County of Sonoma Department of Health Services
 Environmental Health Division
 1030 Center Drive, Suite A, Santa Rosa, CA 95403-2067 (707) 525-6500

Location Address <u>29500 SEAVIEW RD.</u>		City, Zip <u>CAZADERO CA. 95421</u>
Owner/Facility Name <u>ROSS SMITH</u>		Assessor's Parcel # <u>109-200-26</u>
Address of Owner <u>29500 SEAVIEW RD.</u>		City, State, Zip <u>CAZADERO CA. 95421</u>
Person Requesting Service <u>THESE CANELLIS / JOE MERCEIECA</u>		Phone <u>707-632-5708</u>
Address of Person Requesting Service <u>P.O. BOX 186</u>		City, State, Zip <u>CAZADERO CA. 95421</u>
Description <u>SITE REVIEW FOR</u> <u>PERC TEST</u>		
		By

COUNTY OF SONOMA—DEPARTMENT OF HEALTH SERVICES
Pre-Perc Field Notes

Address: 29500 Seaview	Pre-perc date: 8-18-95	Time: 1440
AP#:	Site review by: [Signature]	
Test conducted by: BEIC	Subdivision: Yes <input type="checkbox"/> No <input type="checkbox"/>	Initial <input type="checkbox"/> Supp. <input type="checkbox"/>
Test verified by: HE	Water availability zone: H	
Special standards area:	SCS soil type: HnG	
Topography: Ridge <input type="checkbox"/> Slope <input checked="" type="checkbox"/> Saddle <input type="checkbox"/> Basin <input type="checkbox"/

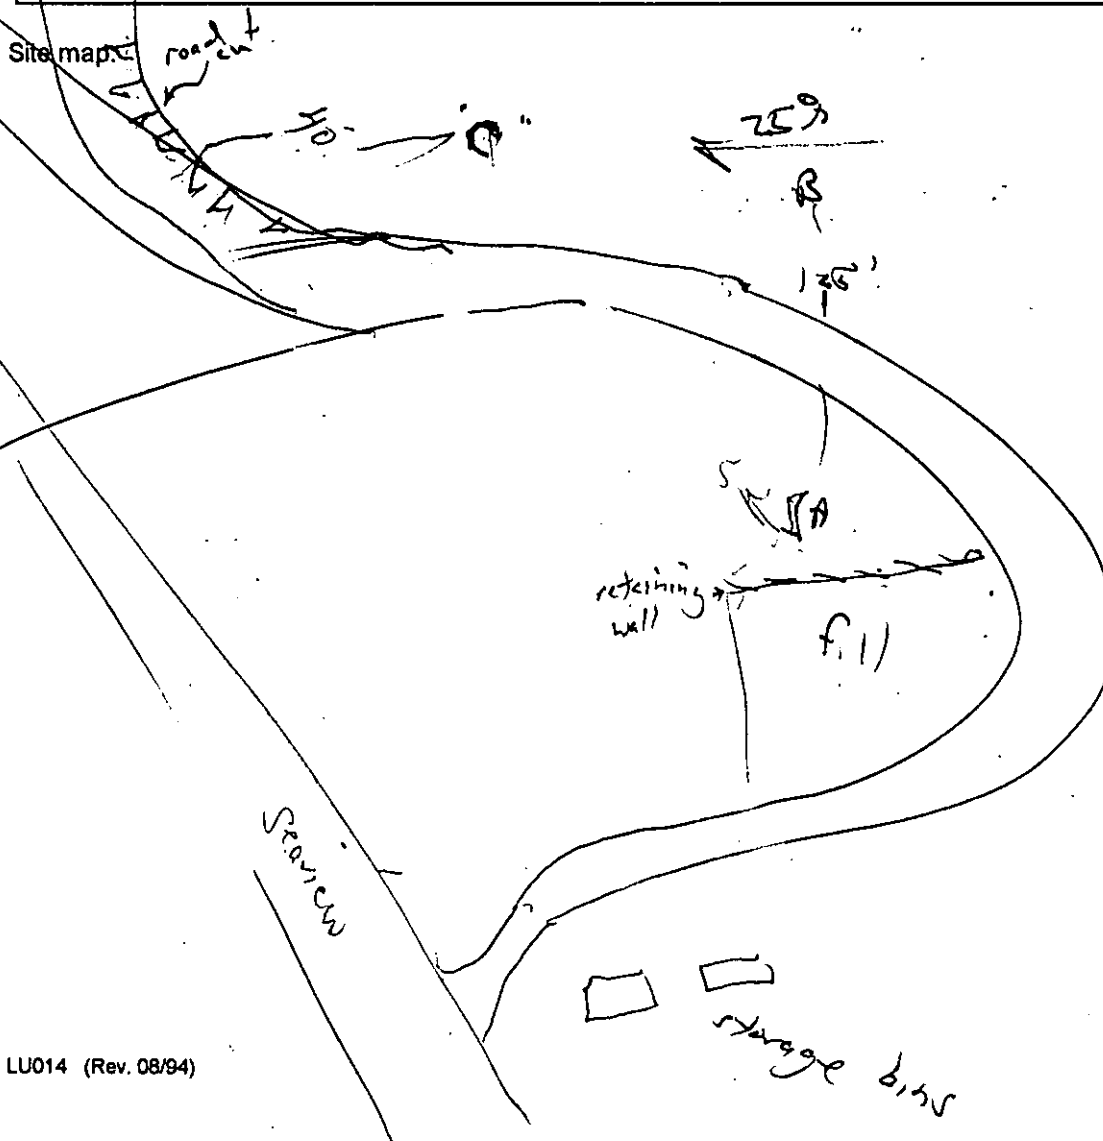
Soil profiles revealed suitable conditions
 to test for 36-62" std septic systems.

Perc trench depth hydro 36-48" profile A.

Proof of water availability req'd.
